Re: Compliance Stormwater Evaluation Inspection
Concrete Supply Co. Greer, South Carolina, Permit SCR005480

U.S. Environmental Protection Agency, Region 4
61 Forsyth Street SW, Atlanta, GA 30303
Water Compliance Inspection Report

CSC Greer ISW 2019
EPA R4 NPDES Inspection Photolog

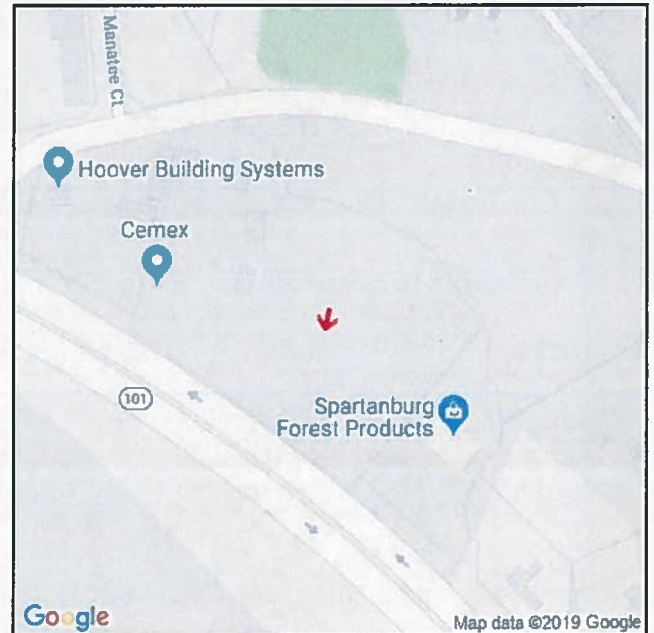
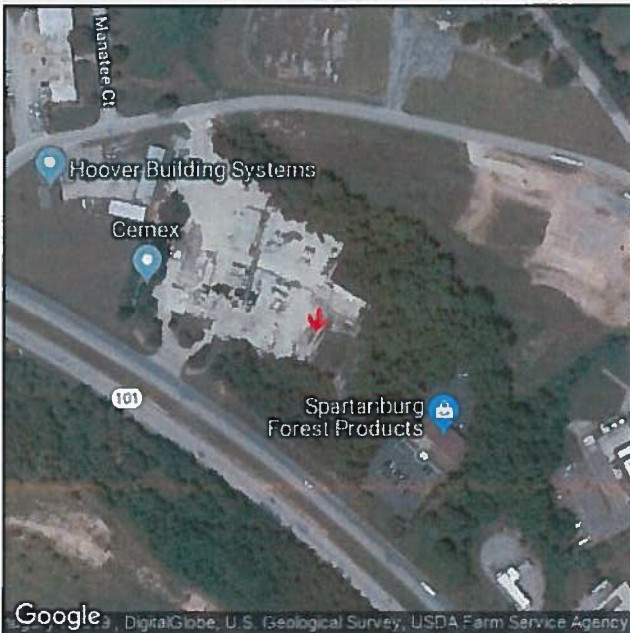
Description	Area to the west of the stormwater collection pond for concrete rubble. Some unused fresh concrete had been wasted to this area recently. That represents a potential path for industrial/process water to exit from pour to the stormwater catch basin. In the photo, the stormwater basin is just off frame to the left (east). Looking southerly.
-------------	--

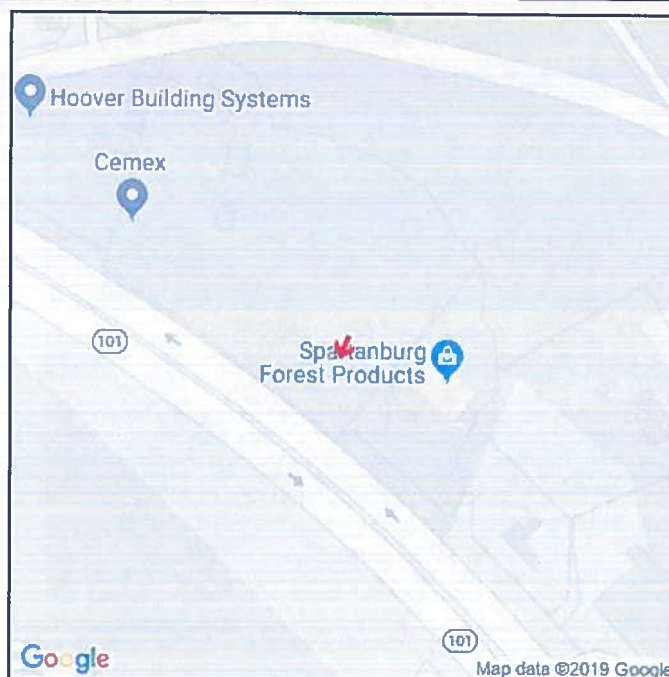
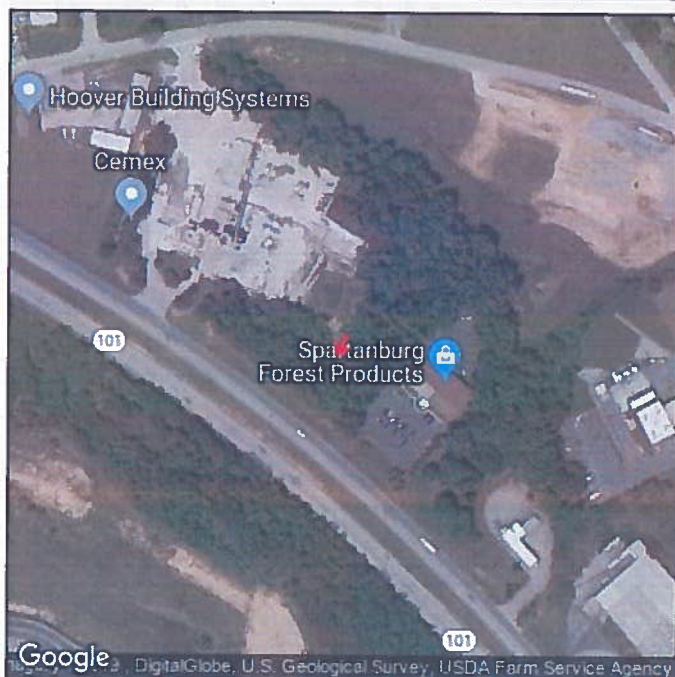
Description	Outlet structure for the stormwater collection pond. White PVC pipe exits the riser shown in DSCN1779 and discharges water here. Not visible: ditch about 20 feet beyond this (circular) discharge spot, and Highway 101 just past that. Samples are taken from this pipe when flowing.
-------------	---

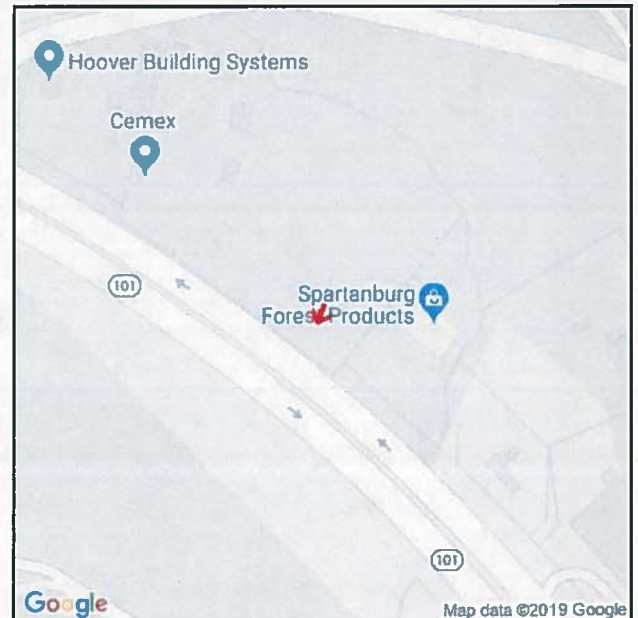
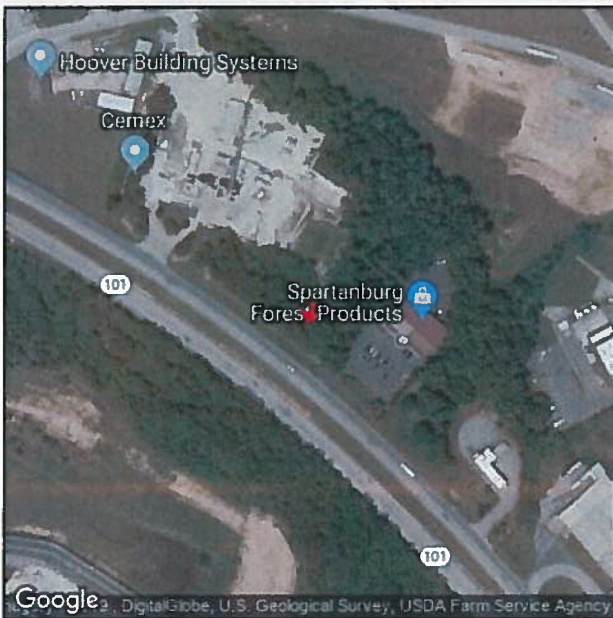
Description	Flow from the outlet location seen in DSCN1782 exits the southerly end of a basin and flows across the surface through the brushy area. Looking more easterly, flow goes from left to right in this picture. Area between gray tree and two darker trees is the bottom of the ditch. Gray residue can be seen on the top of this side of the ditch (gray tree) and on the ditch bottom between the three trees.
-------------	---

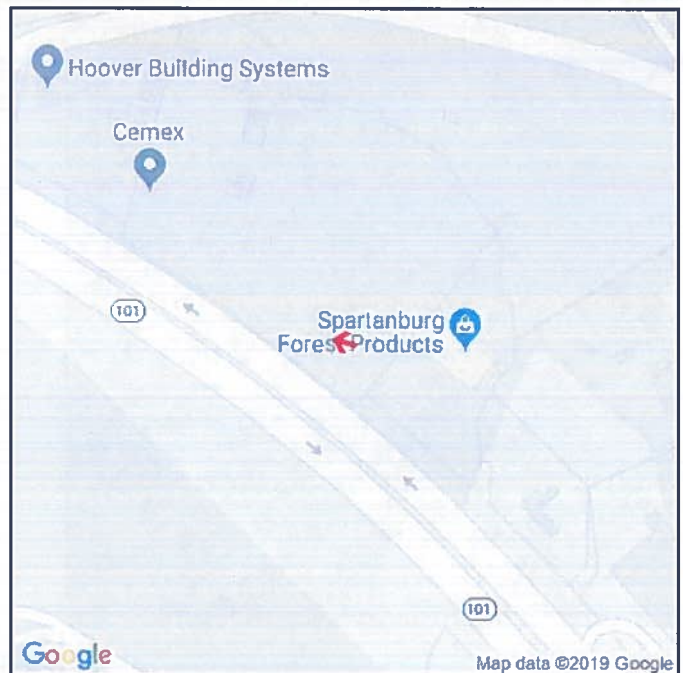
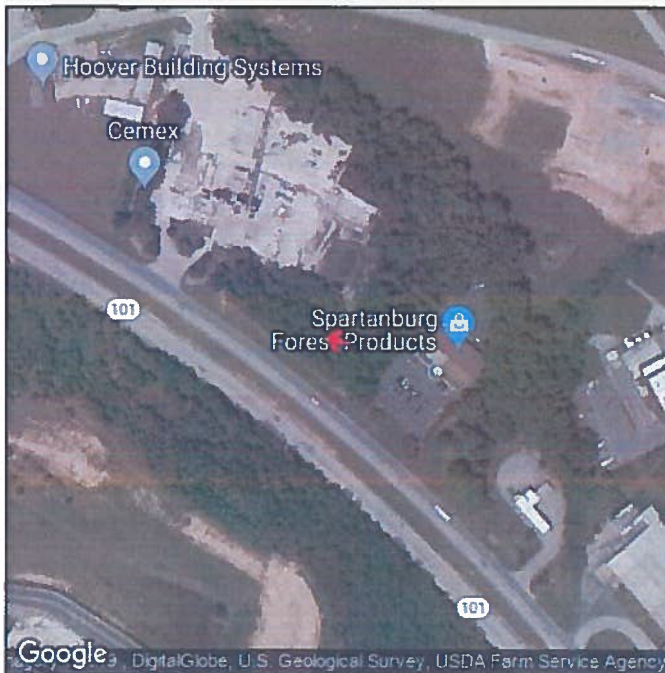
Description	View of residue on bank (center-right) and bottom (near dark tree trunk). Same general location as DSCN1783, viewing from a different angle. Flow enters ditch in this view from right to left.
-------------	---
